Subject: Transmittal of Meeting Minutes - OFFTA Scoping Session November 10, 1998
Naval Station - Newport, Newport Rhode Island

**ATTACHMENT A
MINUTES OF THE MEETING
SURFACE SOIL SAMPLING AND HUMAN HEALTH RISK ASSESSMENT
SITE 09 - OFFTA
Naval Station Newport, Building 1
November 10, 1998**

ATTACHMENT B
OVERSIZE MAP OF SAMPLE LOCATIONS
REVISED AS MARKED UP IN THE FIELD

DRAWN BY: R.G. DEWSNAP		TITLE: PROPOSED SURFACE SOIL SAMPLE LOCATIONS	
PREPARED BY: D. McKENNA		OLD FIRE FIGHTING TRAINING AREA	
CHECKED BY: S. PARKER		NETC, NEWPORT, RHODE ISLAND	
PROJECT MANAGER: D. McKENNA		SOURCE: BASE PLAN BY GUERRIERE & HALNON, INC., JULY 1997	
PROGRAM MANAGER: J. TREPANOWSKI		SCALE: 1" = 40'	DATE: NOVEMBER 13, 1998
		DRAWING NO: 2	PROJ. NO: 5278 CTO: 218
		ACFILE NAME: \DWG\NETC\FIREFITE\SS_PROP.DWG	REV: 0

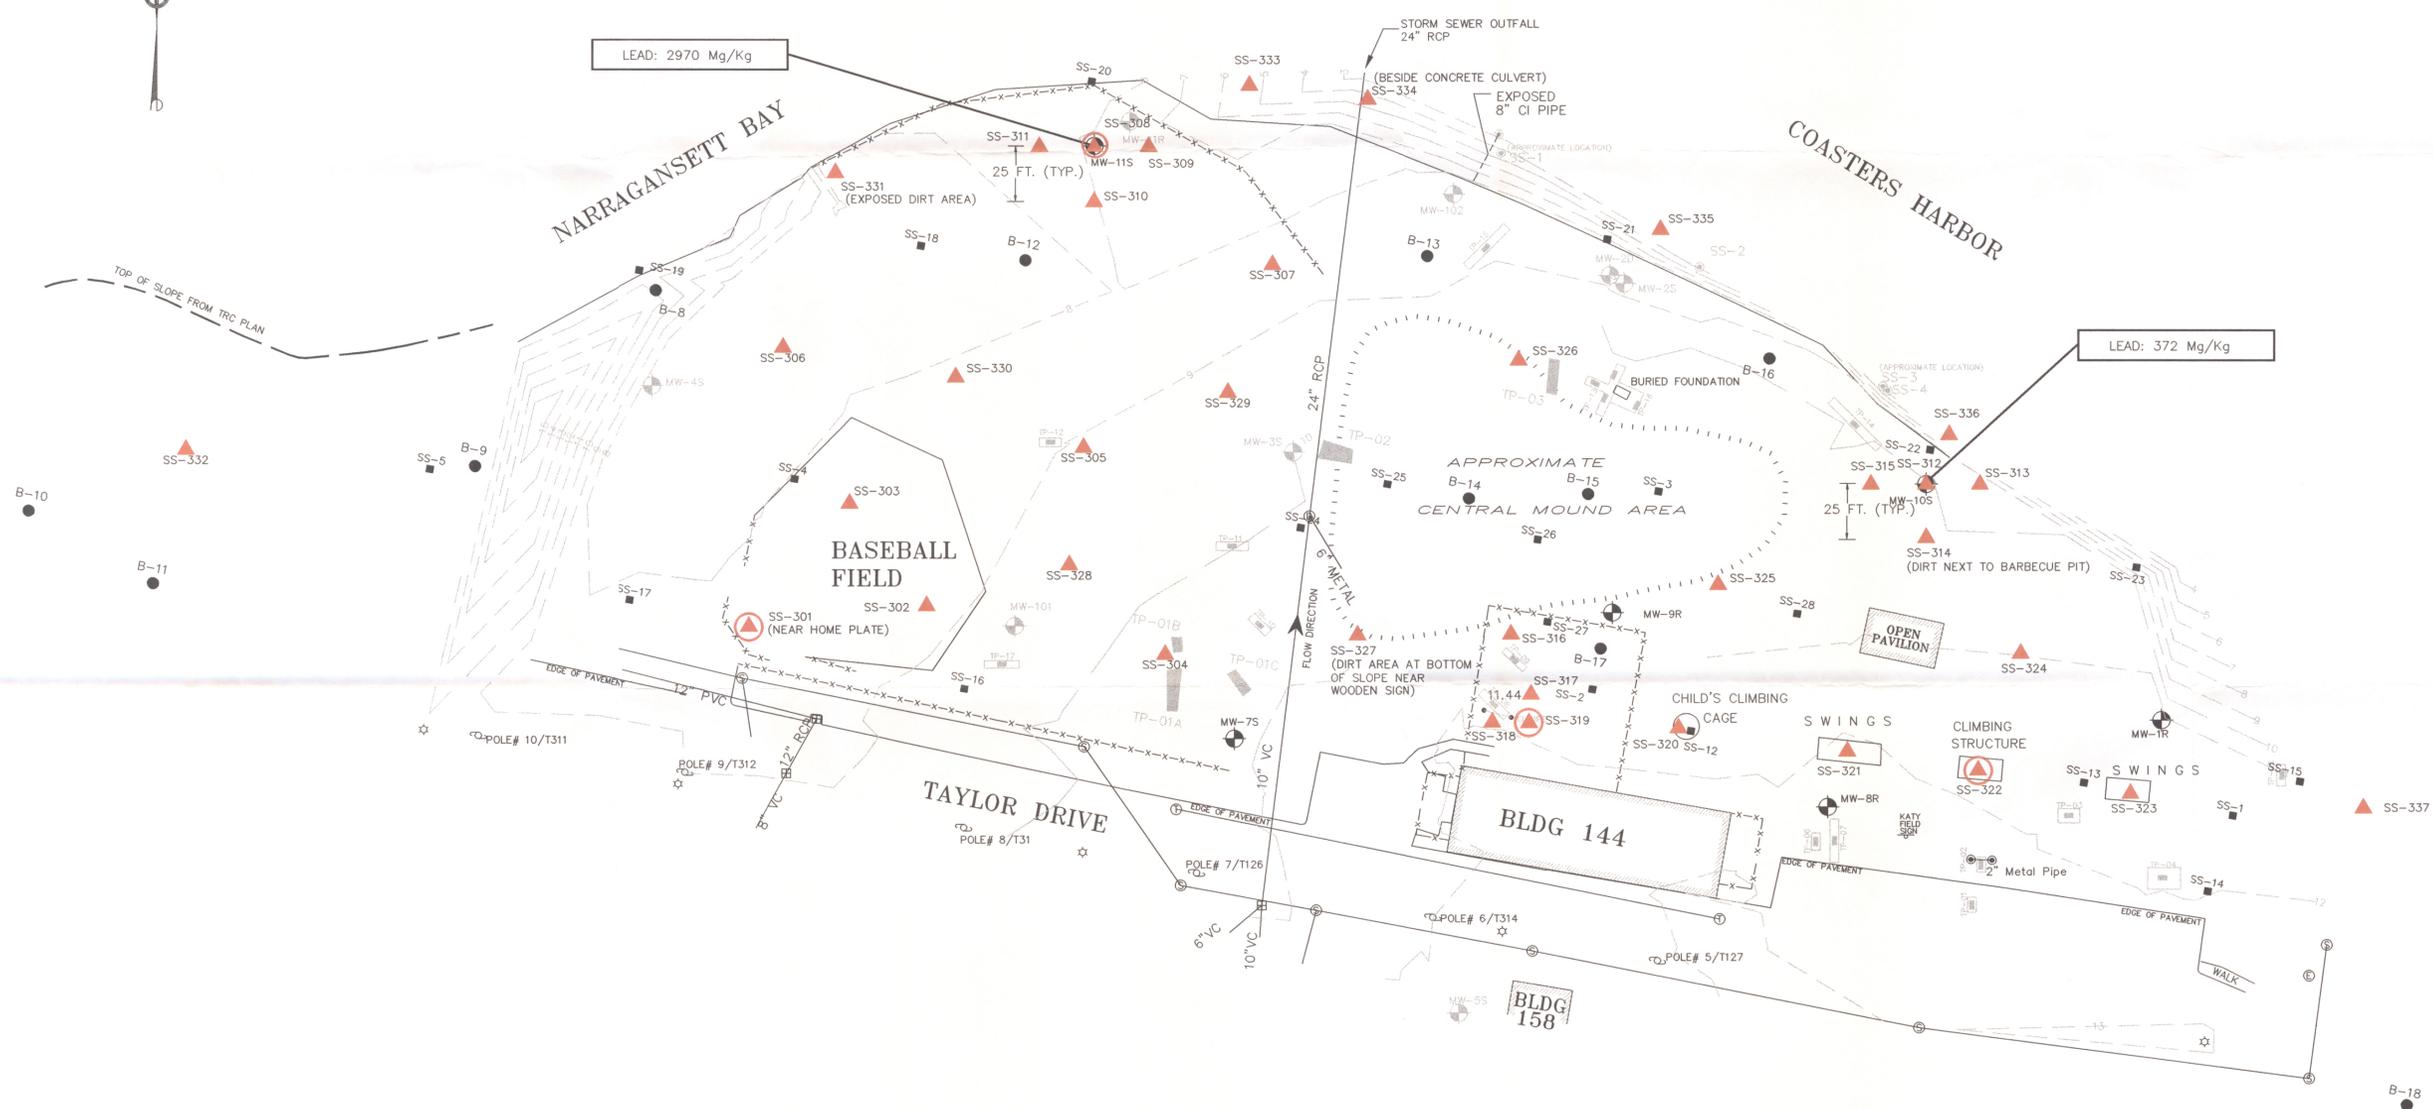
1. Agreed to the 24 locations proposed by TTNUS (identified as 300 series samples), with the following modifications:
 - stations 302 and 303 shifted slightly to align with the infield of the baseball field,

- stations 316, 317, 318, and 319, within the fenced toddler play-area, shifted so that three samples are collected beneath the playground equipment and the fourth sample is collected from the sandy area between the playground structures.

2. Agreed to five additional stations proposed by USEPA
3. Agreed to two additional stations proposed by RIDEM
4. Agreed to five additional stations at the shoreline (in the intertidal zone) proposed by RIDEM and EPA

5. RIDEM requested that the shoreline seep identified by TTNUS personnel (and discussed with P. Kulpa) in the field in 1997 be sampled (note: this matter was reviewed by TTNUS, and the seep recalled by P.Kulpa is actually a sheen that was observed around the concrete culvert located to the north east of the ballfield). A sample is proposed for this culvert to address this potential seep.

6. Dioxins were added to the analyte list for Stations 301, 308, 319, and 322.
7. It was clearly stated that samples would be collected from the 0-1 foot sample interval. ATSDR preference for shallower samples (0-3 inches) and RIDEM request for deeper samples (0-2 feet) was noted. J. Shafer indicated that this issue would have to be elevated to another management level with RIDEM.
